PLANNING REPORT

Architectural Review Board

JAMES DAVIS HOUSE ADDITION 23-022ARB-MPR

North and South Elevations

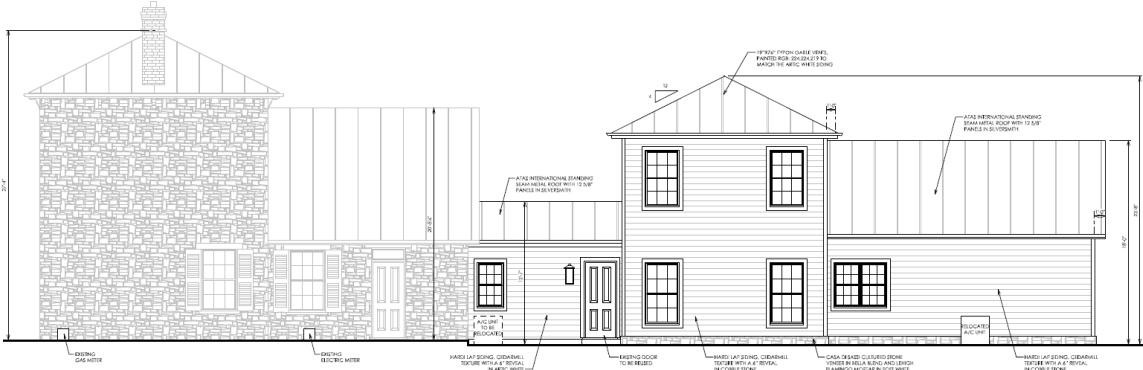
The northern elevation below in Option A shows the hip-gabled historic façade facing Dublin Road and a side-gabled one-and-a-half-story form at the rear. The 6:12 pitch, side gable hyphen connects the rear façade of the historic home to the proposed two-story building addition, which has a reduced-width hyphen and connects the two-story addition and a two-car garage at the rear. This hyphen provides an appropriate break between the new and old structures, as anticipated in Guidelines Section 4.12C.

The main portion of the addition, parallel to Dublin Road, has a roof pitch of 6:12 and a building height of 22 feet, 7 inches. The rear portion has pitches of 3:12, 4:12, and 6:12. Staff recommended simplifying the rear roof pitch further, and the applicant has provided Option B to show a different alternatives.

Staff recommended simplifying the roof pitches to be more in keeping with the simplicity of the historic structure with a potential solution of using a hipped gable form for the main portion of the addition and a single gable for the garage. The applicant explored the staff-requested changes with Option B using the hipped gable and removing the shed roof on the garage. This results in the main addition to the house being taller; however, it matches the iconic form of the historic house and appears to be more subordinate in overall massing. The design alternatives are demonstrated in Options A and B below.

Option A - South Elevation

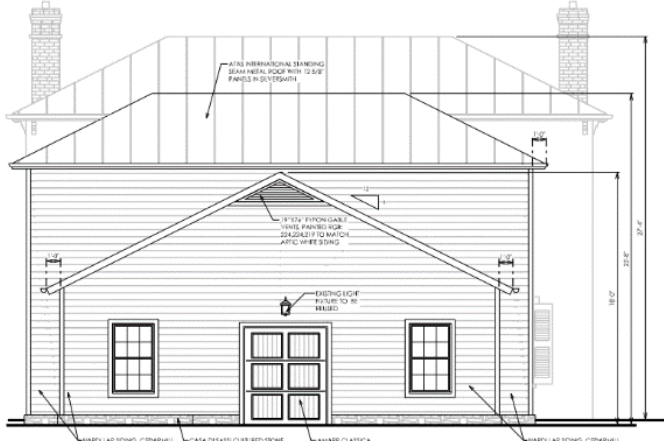
As outlined above, staff recommends simplifying the garage roof pitches to be more in keeping with the simplicity of the historic structure, which is demonstrated in the two design options.

Staff summarized the design options below for the roof of the addition and the attached garage. Staff looked to the Historic Design Guidelines, Section 5.3 regarding roof pitch and form to inform the design, especially that the design should be similar to the surrounding building. The historic home has a hip gable roof and a front gable at the rear. Design B or a hybrid option could help create a cohesive design form that aligns more clearly with the Guidelines.
